Service Information

Category S	Repair Guidance		Ref. No. R020/12	Page 1 of 3
Coverage ☐ Distributor only ■ Please inform your dealers			Date Issued March 1, 2012	
Please convey this information to your ☐ Director ☐ General ☐ Warranty Dept. ☐ Parts Dept. ☐ Training Dept. ☐ Field I		l Manager Rep.	Date Revised	
Applicable Model		Applicable Countries or Specifications		
CX-5 (KE)		Europe and North America

Subject: Large Clearance on top of A-pillar Trim

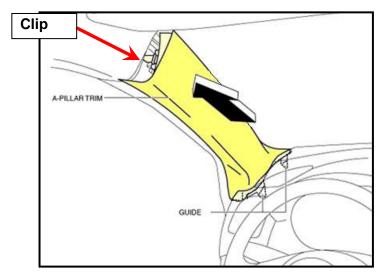
Some vehicles may exhibit large clearance on top of A-pillar which gives poor appearance as shown below.

A-pillar trim clip did not fit properly due to a piece of curtain air bag caught in the clip.

A piece of curtain air bag has been fixed.

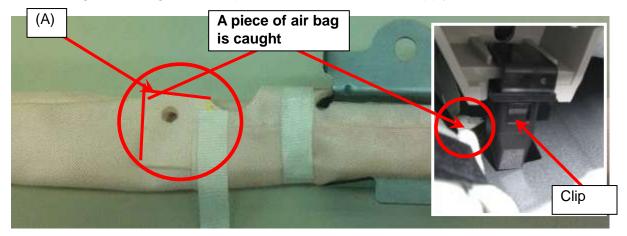
1. Remove the A-pillar trim according to workshop manual.

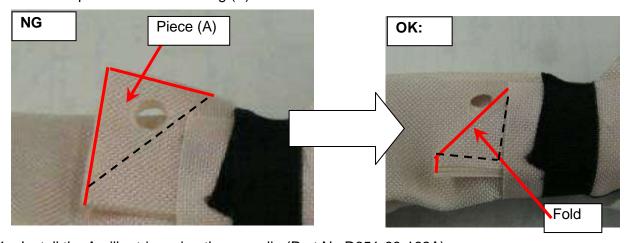
2. If a piece of curtain air bag (A) is caught in the clip, go to next step. (If air bag is not caught in the clip, this information does not apply.)

3. Fold the piece of curtain air bag (A).

4. Install the A-pillar trim using the new clip (Part No.D651-68-162A).
